Identification cards — Test methods —

Proximity cards

**AMENDMENT 4: Additional test methods for
PCD RF interface and PICC alternating field
exposure**

Amendment 4 to ISO/IEC 10373-6:2001 was prepared by Joint Technical Committee ISO/IEC JTC 1, *Information technology*, Subcommittee SC 17, *Cards and personal identification*.

Figure 1 — ESD test circuit

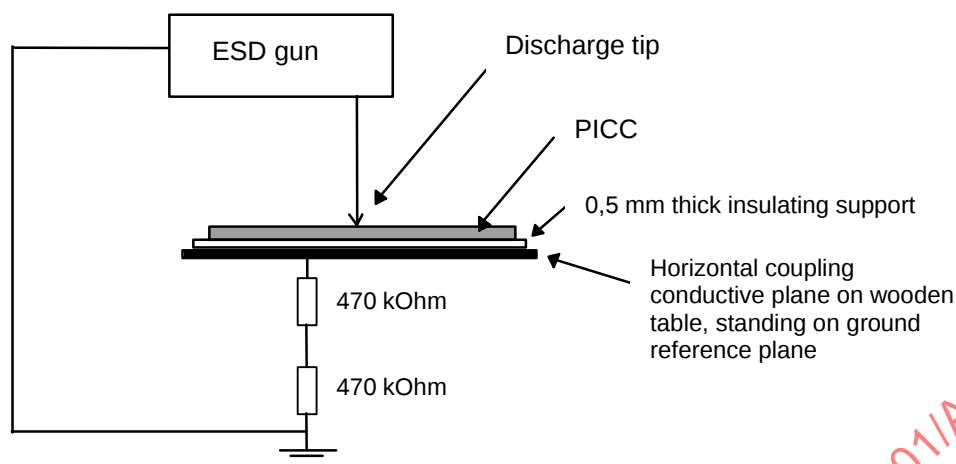
Replace Clause 5 and subclauses 5.1, 5.2 and 5.3 with the following:

5.3 Static electricity test

The purpose of this test is to check the behaviour of the card IC in relation to electrostatic discharge (ESD) exposure in the test sample. The PICC under test is exposed to a simulated electrostatic discharge (ESD, human body model) and its basic operation checked following the exposure.

5.3.1 Apparatus

Refer to IEC 61000-4-2:1995.

a) Main specifications of the ESD generator:

- energy storage capacitance: $150 \text{ pF} \pm 10 \%$;
- discharge resistance: $330 \Omega \pm 10 \%$;
- charging resistance: between $50 \text{ M}\Omega$ and $100 \text{ M}\Omega$;
- rise time: $0,7 \text{ ns}$ to 1 ns .

Figure 2 — Test zones on PICC for ESD test

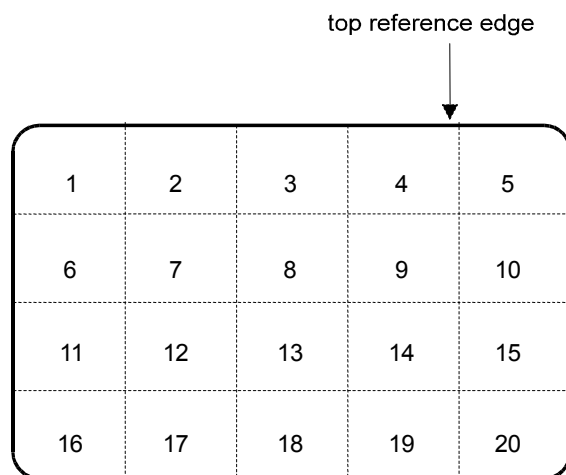
5.3.2 Test procedure

Connect the ground pin of the apparatus to the conductive plate upon which the PICC is placed.

Apply the discharge successively in normal polarity to each of the 20 test zones shown in Figure 2. Then repeat the same procedure with reversed polarity. Allow a cool-down period between successive pulses of at least 10 s .

WARNING — If the PICC includes contacts, the contacts should face up and the zone which includes contacts should not be exposed to this discharge.

Check that the PICC operates as intended at the end of the test.
